City of Richmond Hill
Building Division

These drawings have been reviewed under
Compliance Option: **PERFORMANCE**
of the OBC 2012, SB-12.

38-11 Belvedere

Centrefield, Ph. 2

BASEMENT FLOOR PLAN ELEV. 'A'

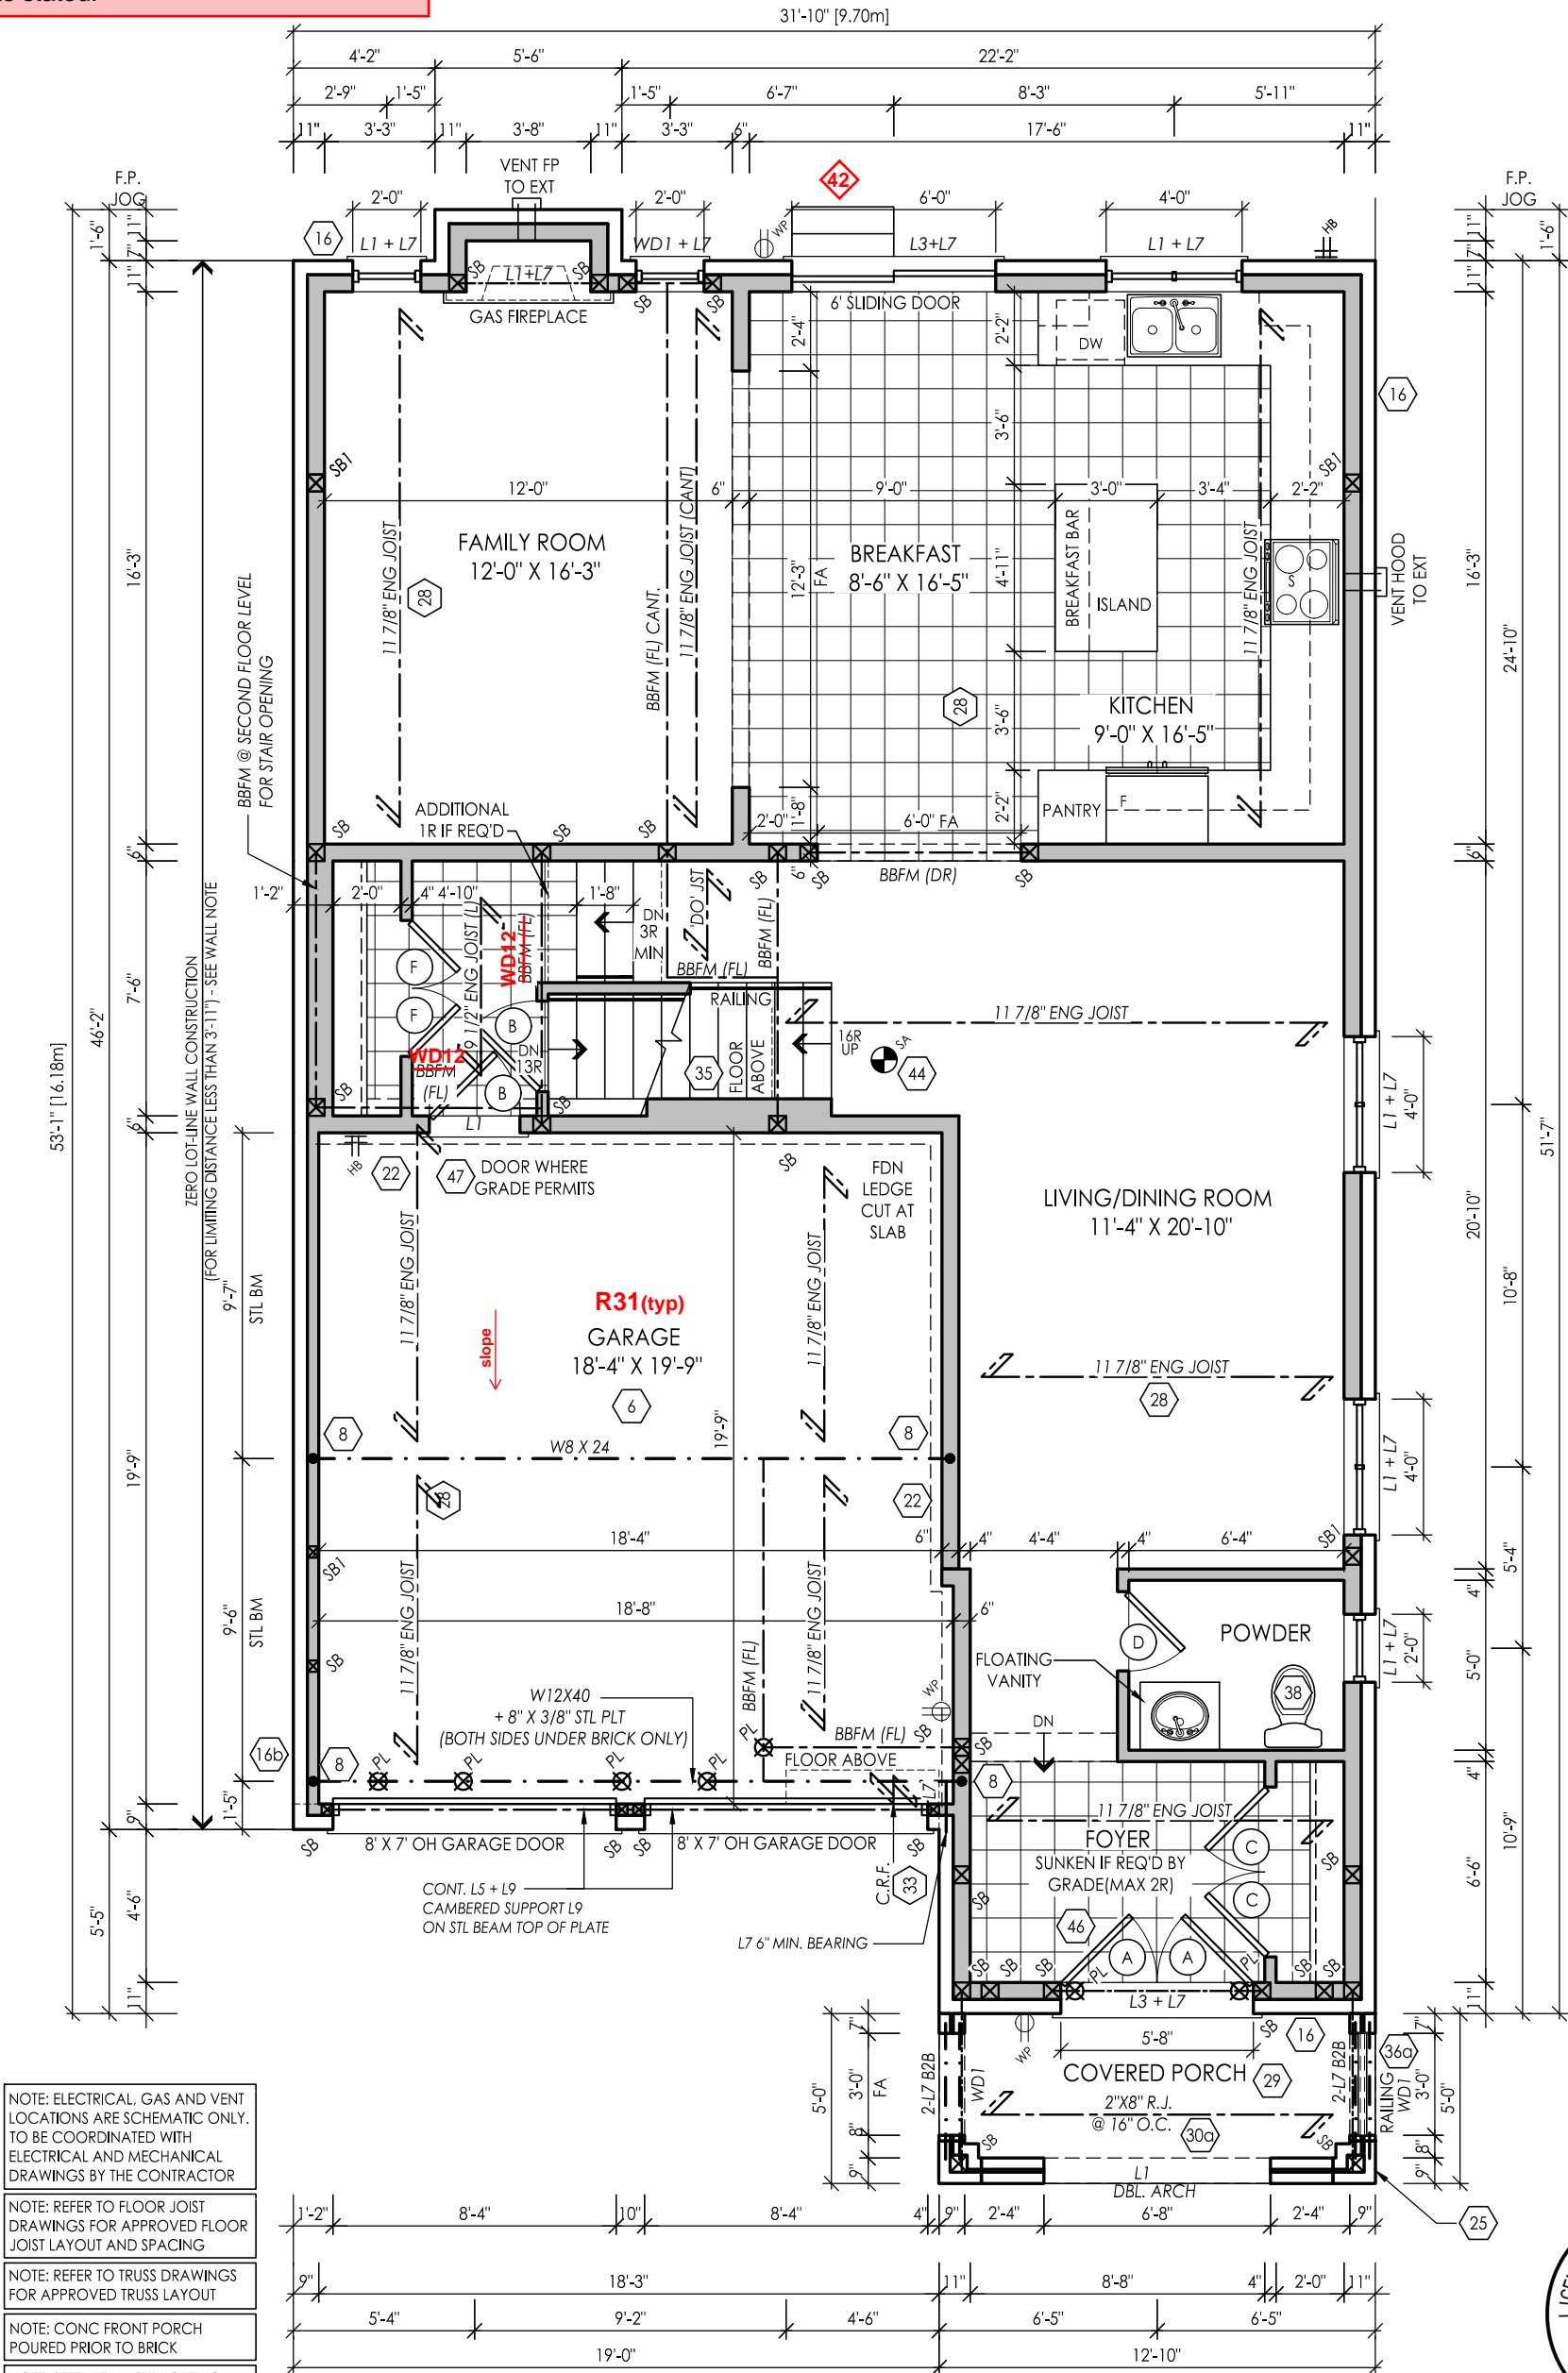
All interior stairs require a guard on both sides as per sentence 9.8.8.1.(3) of the Ontario Building Code.

GROUND FLOOR PLAN ELEV. 'A'

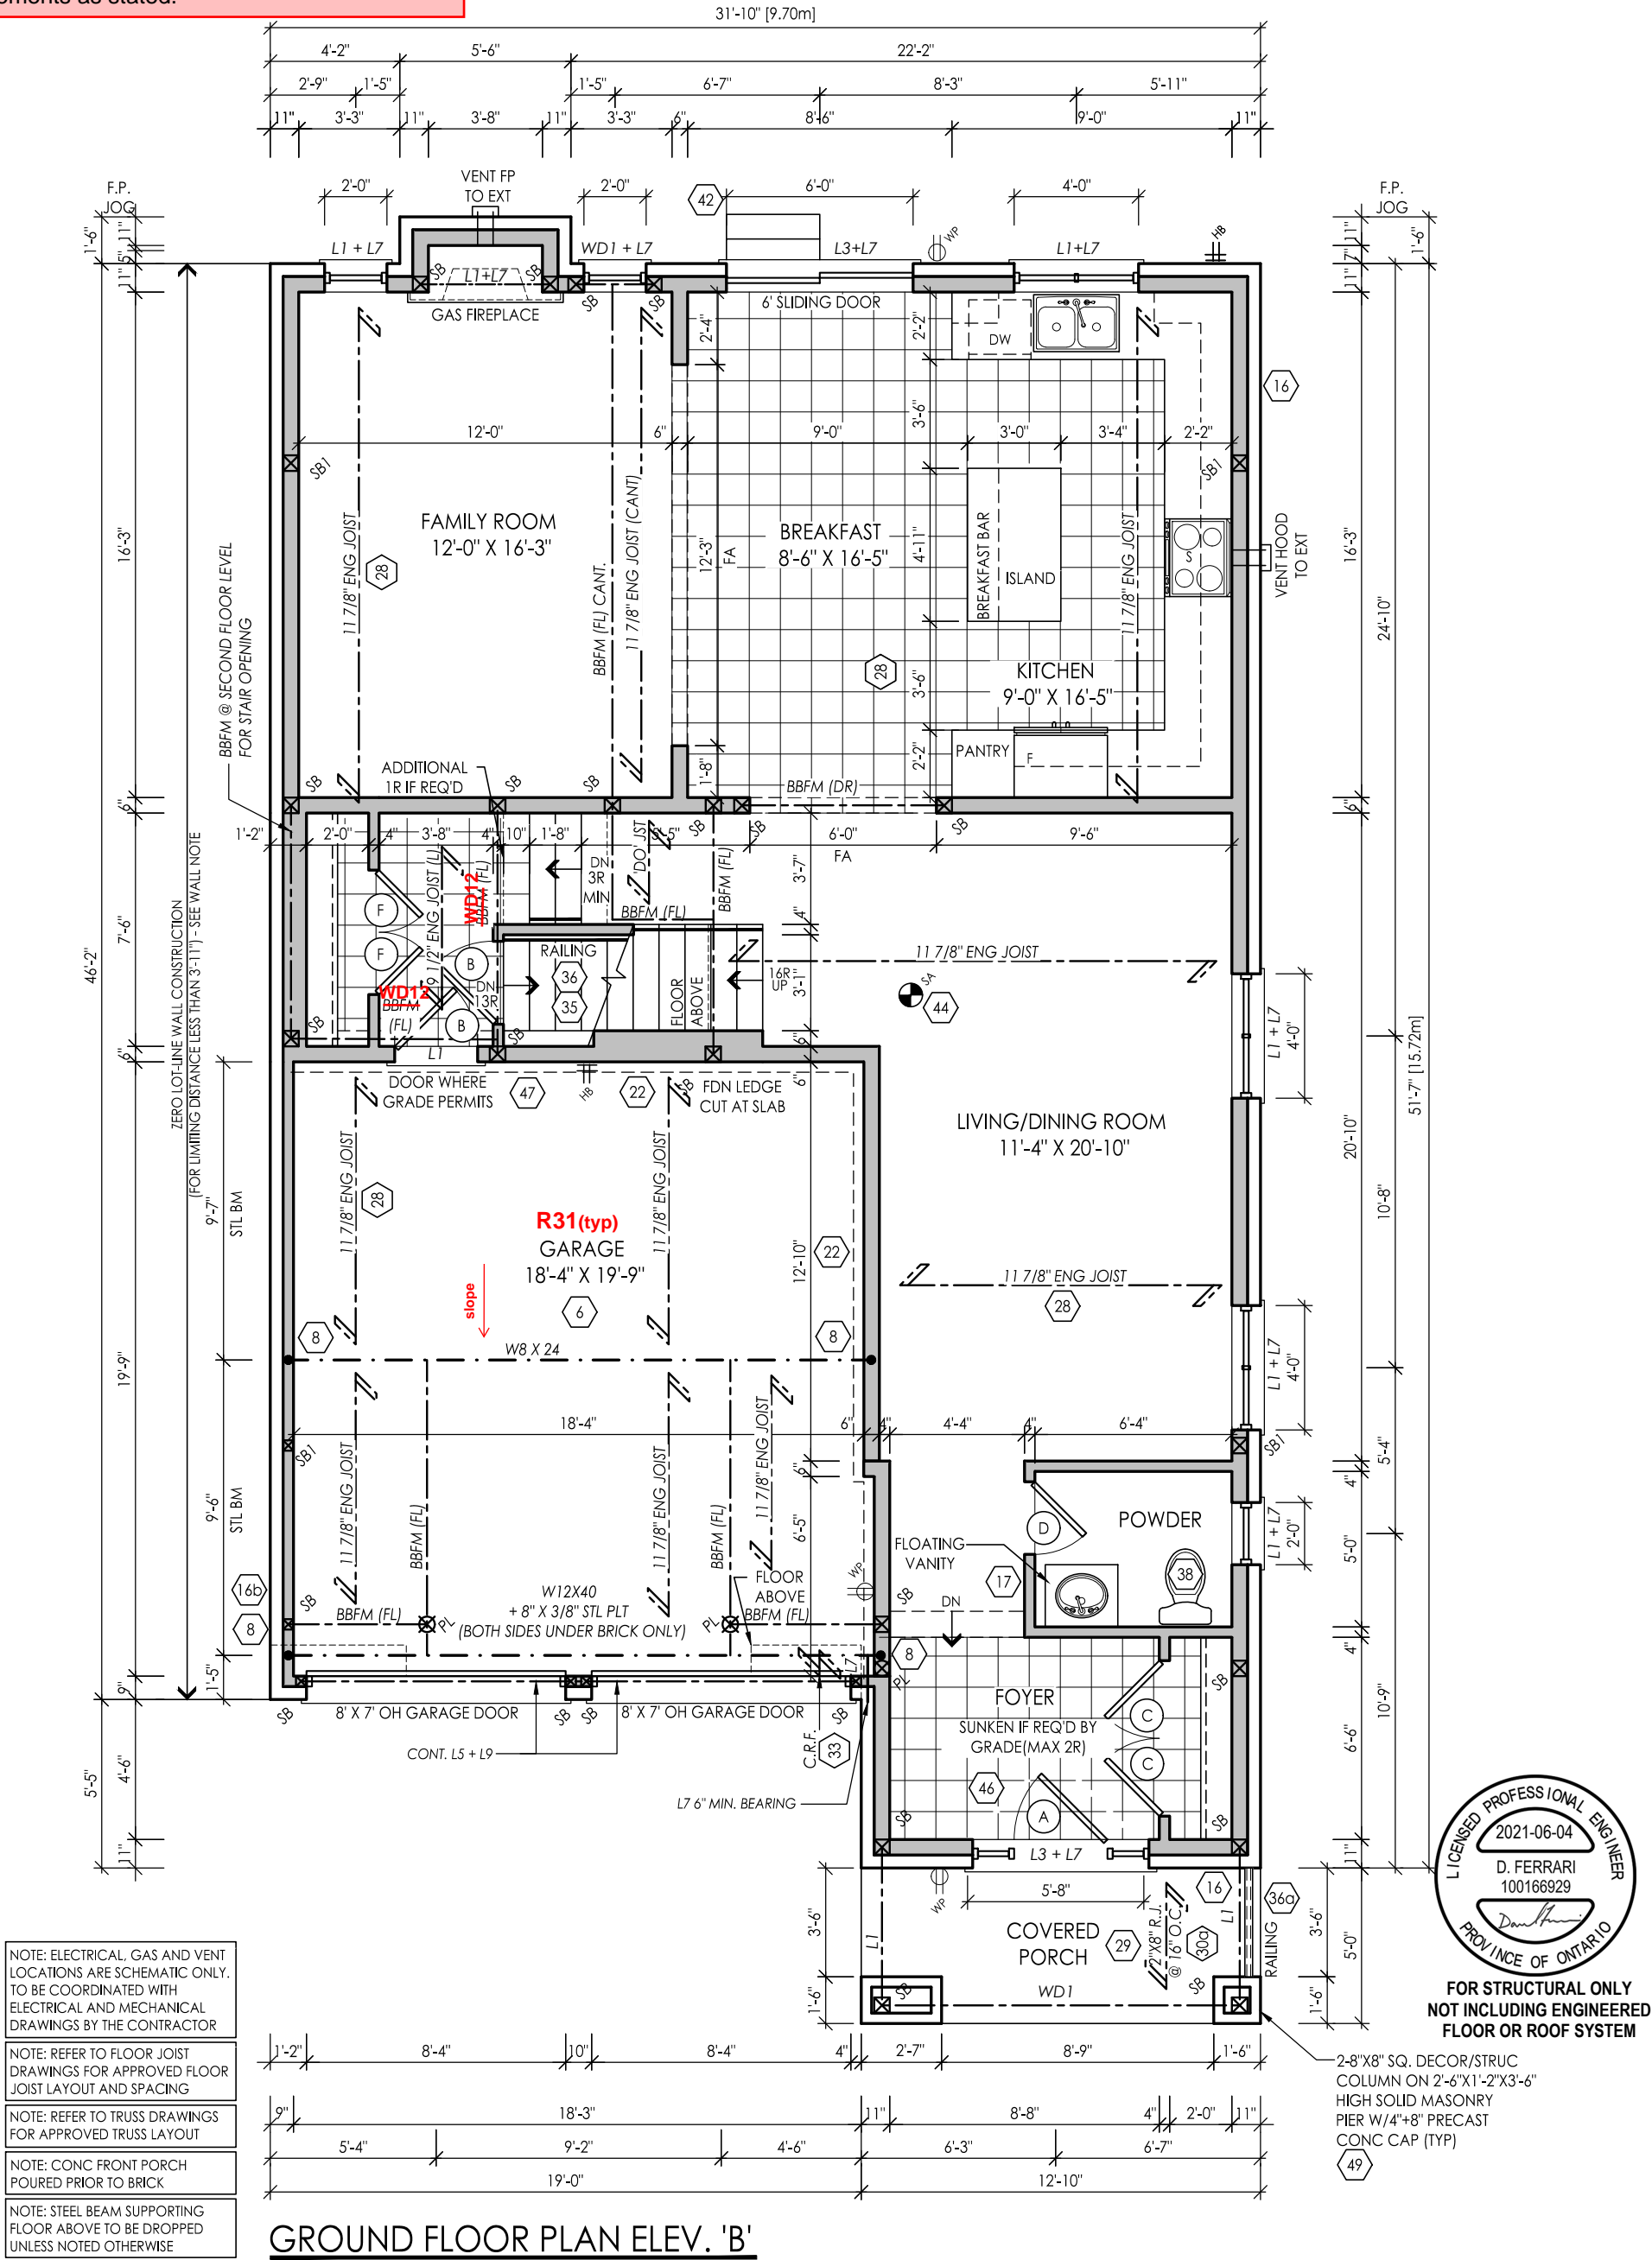
All doors between the garage and living space shall have self-closing devices. If required to have stairs, stairs shall conform to Section 9.8 of the Ontario Building Code.

RIGHT SIDE ELEVATION 'A'

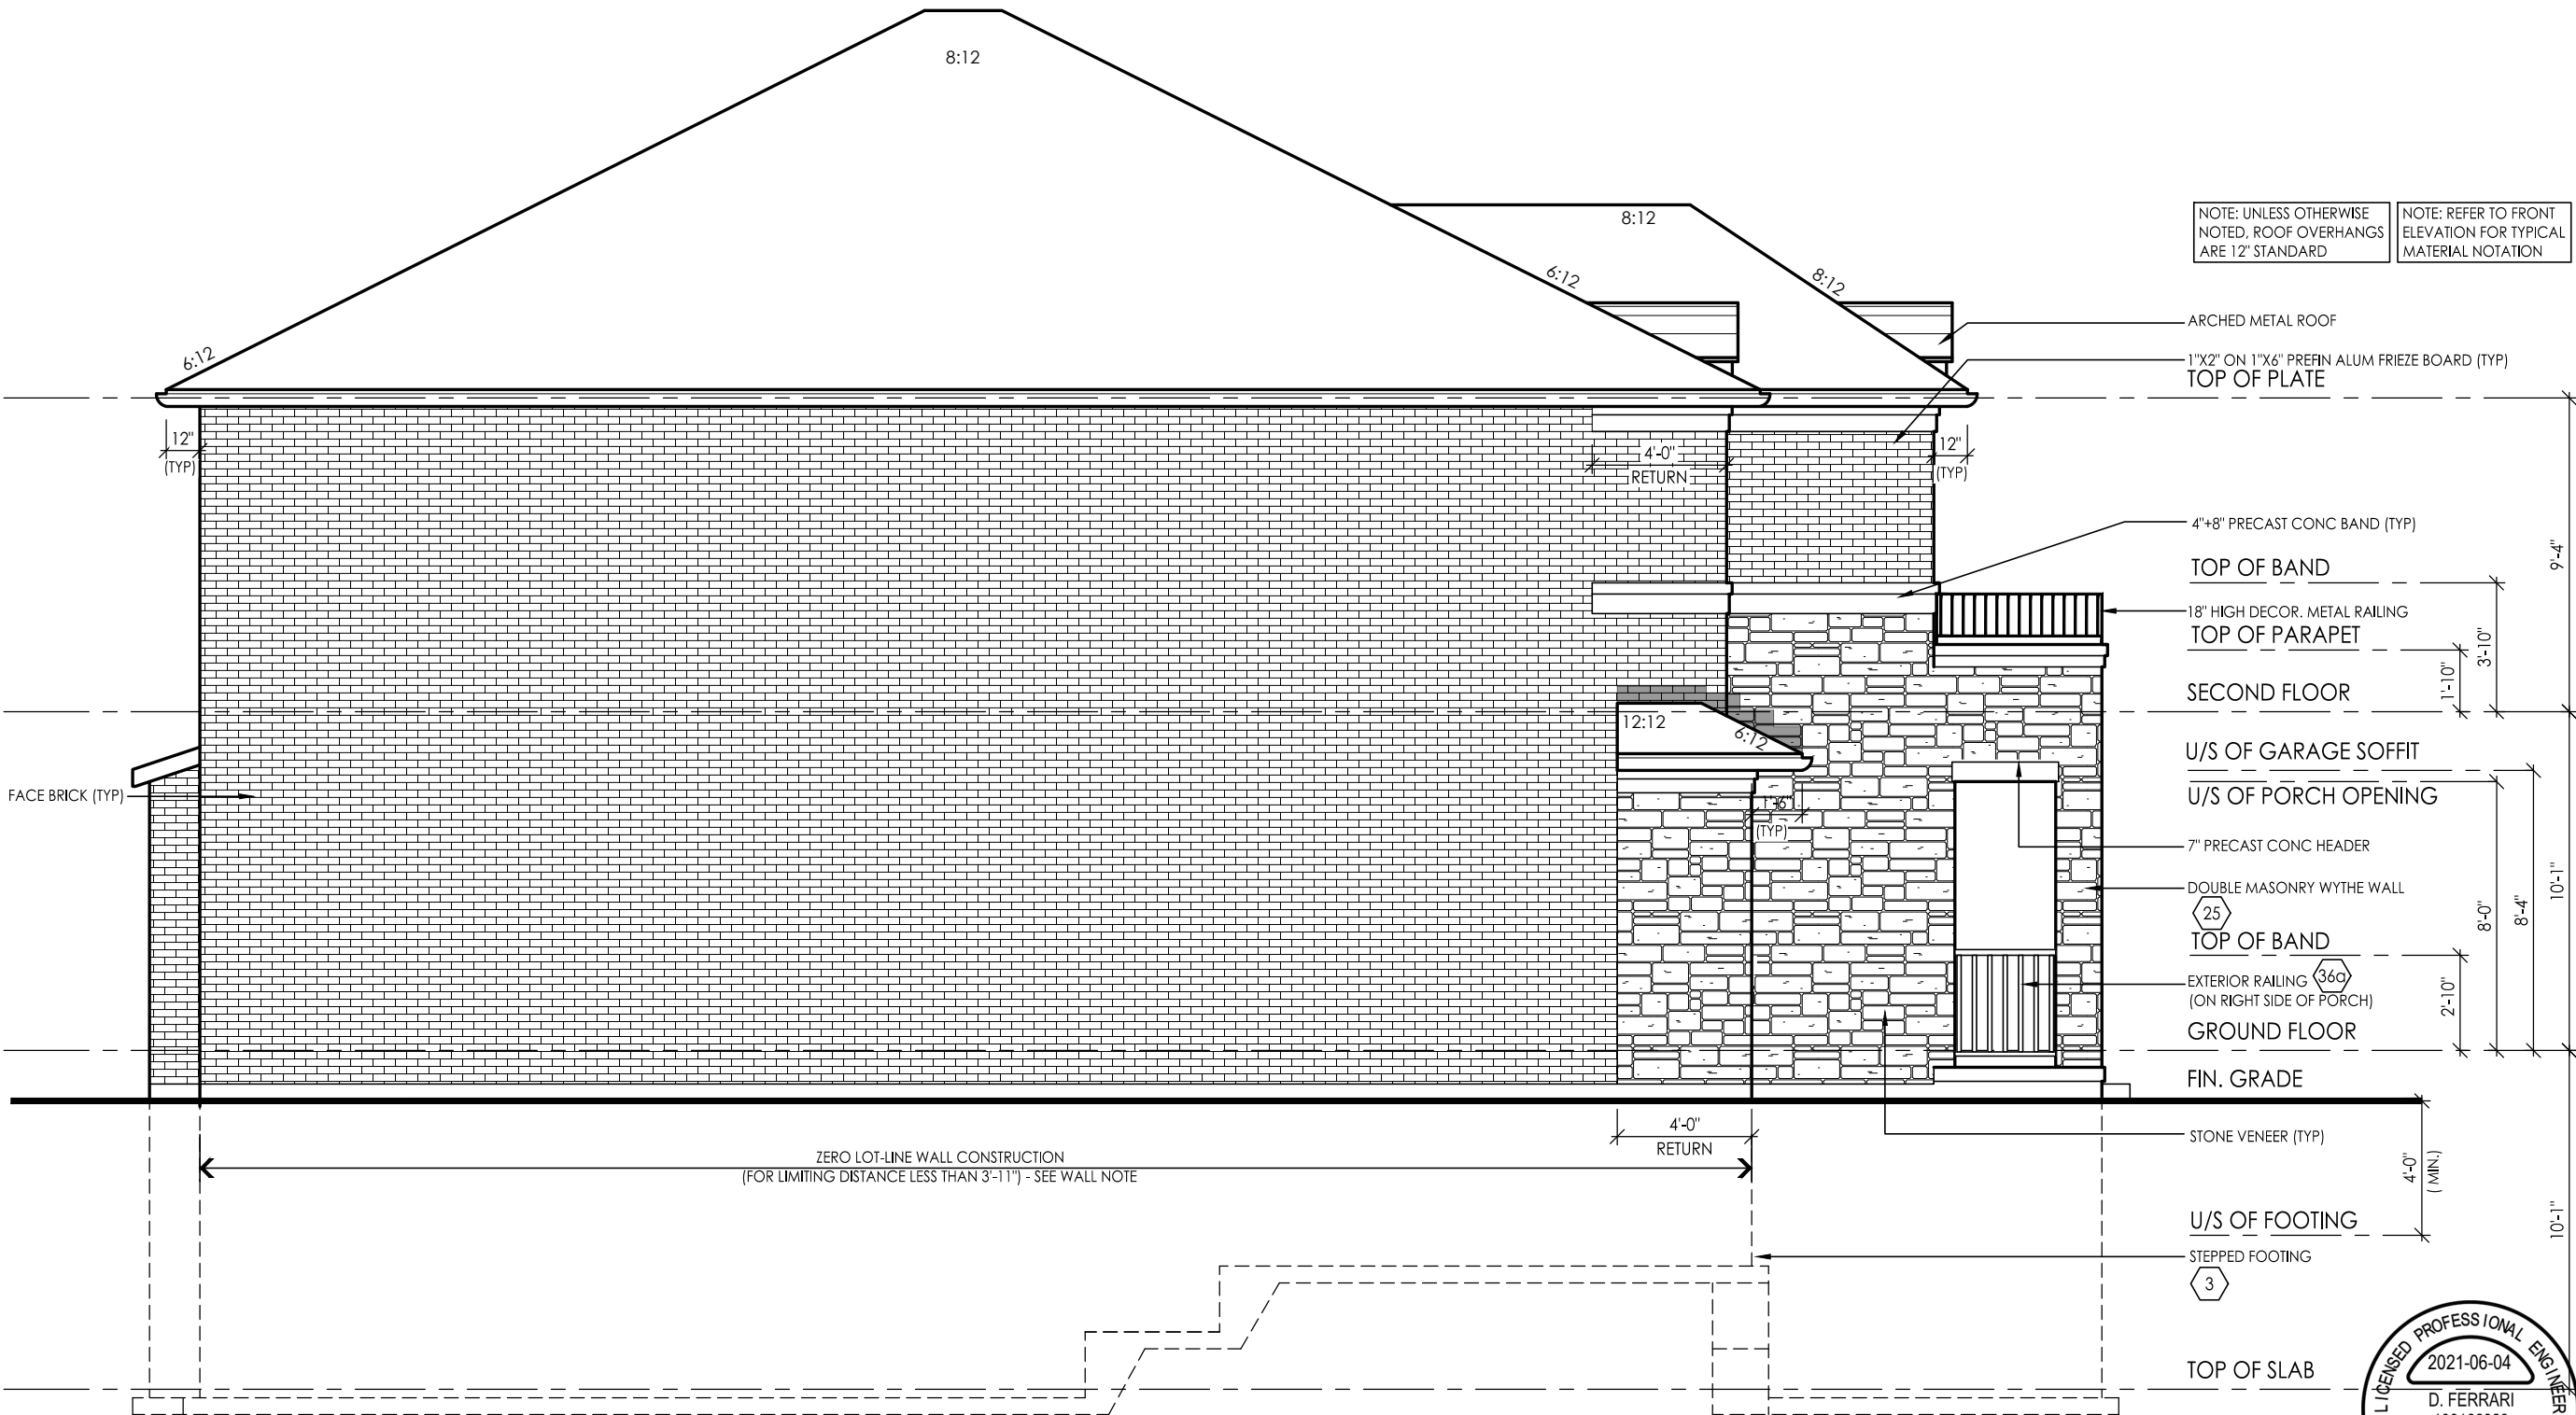
No unprotected openings permitted within 1.2 meters of the lot line as per article 9.10.14 of the Ontario Building Code.

LEFT SIDE ELEVATION 'A'

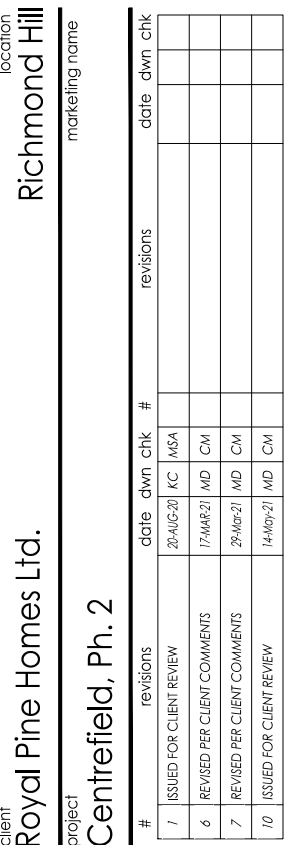
No unprotected openings permitted within 1.2 meters of the lot line as per article 9.10.14 of the Ontario Building Code.
